MONTICELLO NUCLEAR GENERATING PLANT
Docket No. 50-263 License No. DPR-22

License Amendment Request Dated April 23, 1976

REQUEST FOR AMENDMENT TO
OPERATING LICENSE NO. DPR-22

PROPOSED CHANGES TO TECHNICAL SPECIFICATIONS
APPENDIX A OF PROVISIONAL OPERATING
LICENSE NO. DPR-22

Figure 3.11.2
LHGR Versus Core Height

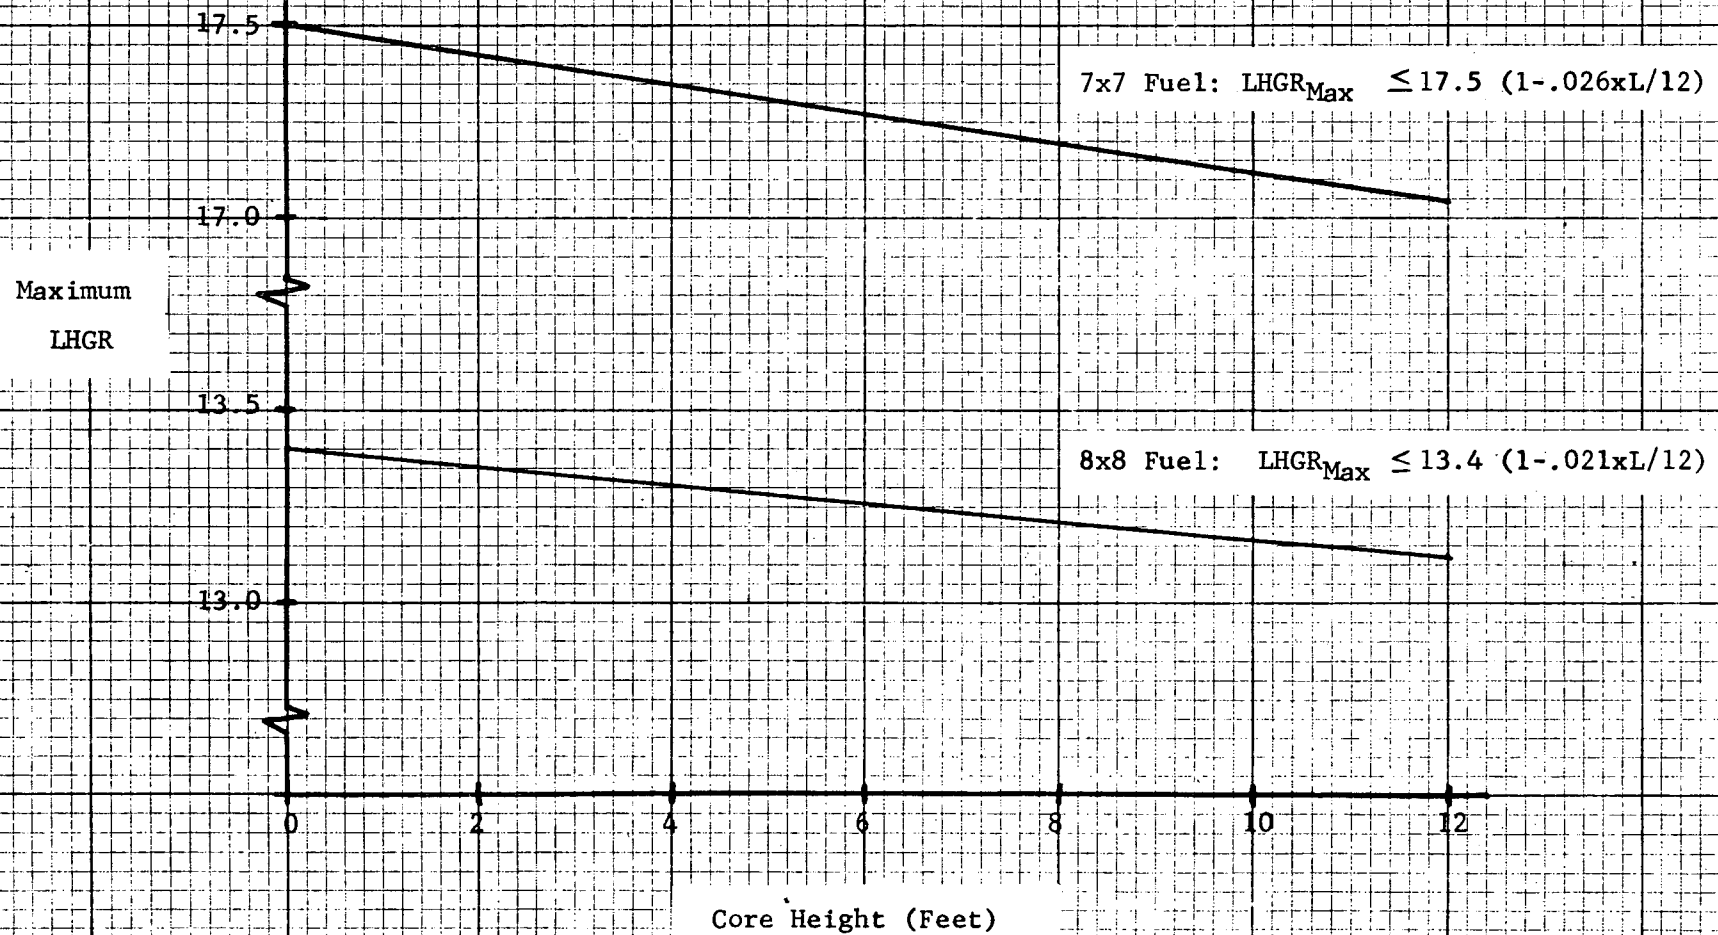
Figure 3.11.2 (Page 189L)

Insert the new Figure 3.11.2, "LHGR vs Core Height", on the page 189L which was vacated by the above change.

During steady state power operation, the LHGR as a function of core height shall not exceed the limiting value shown in Figure 3.11.2. If at any time during operation it is determined that the limiting value for LHGR is being exceeded, action shall be initiated within 15 minutes to restore operation to within the prescribed limits. Surveillance and corresponding action shall continue until reactor operation is within the prescribed limits. If the LHGR is not returned to within the prescribed limits within two (2) hours, the reactor shall be brought to the Cold Shutdown condition within 36 hours.

Figure 3.11.3
 K_f Factor Versus Percent
 of Rated Core Flow

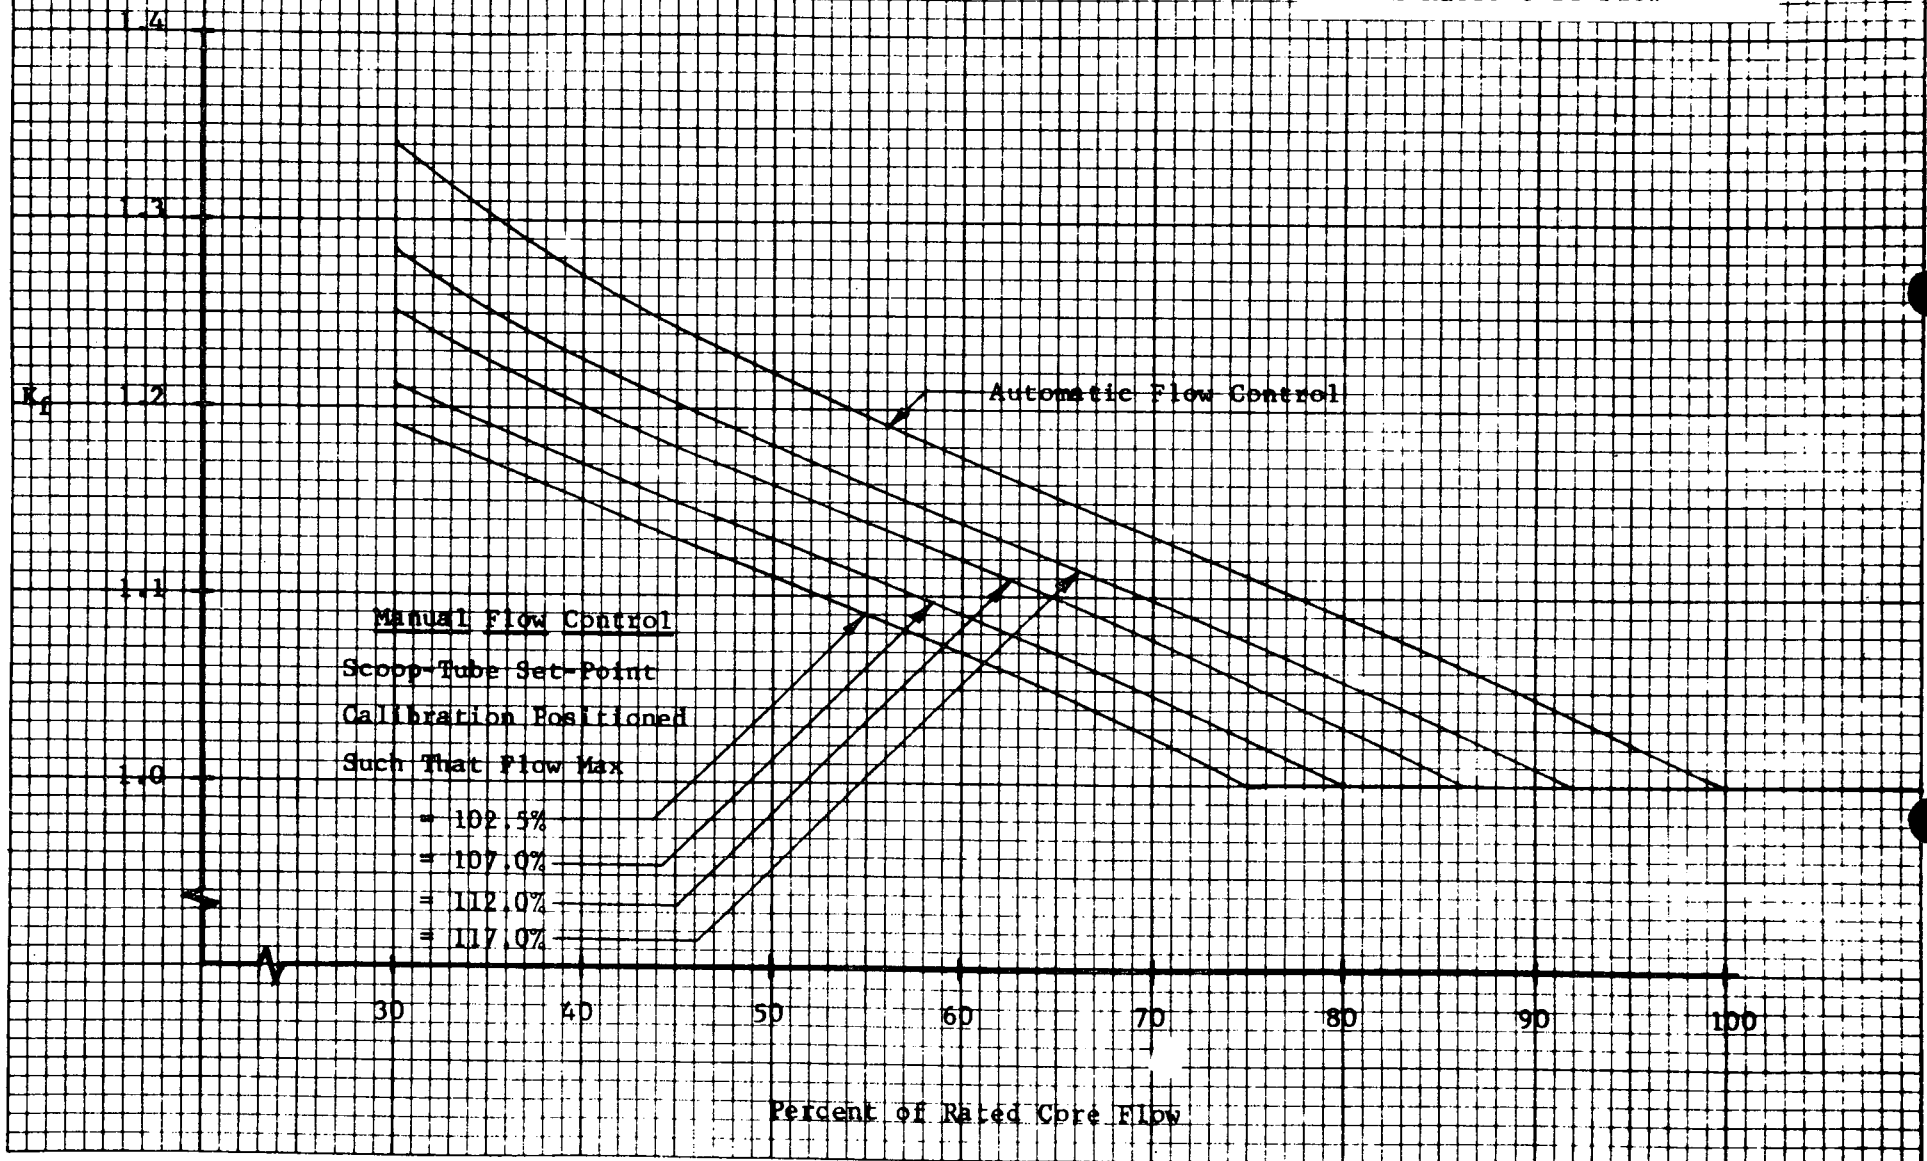
Former Figure 3.11.2 (Page 189M)

Change the number of the figure entitled " K_f Factor versus Percent of Rated Core Flow" from Figure 3.11.2 to Figure 3.11.3.

During steady state power operation, the Operating MCPR Limit shall be ≥ 1.38 for 8x8 fuel and ≥ 1.29 for 7x7 fuel at rated power and flow. If at any time during operation it is determined that the limiting value for MCPR is being exceeded, action shall be initiated within 15 minutes to restore operation to within the prescribed limits. Surveillance and corresponding action shall continue until reactor operation is within the prescribed limits. If the steady state MCPR is not returned to within the prescribed limits within two (2) hours, the reactor shall be brought to the Cold Shutdown condition within 36 hours. For core flows other than rated the Operating MCPR Limit shall be the above value times K_f where K_f is as shown in Figure 3.11.3.
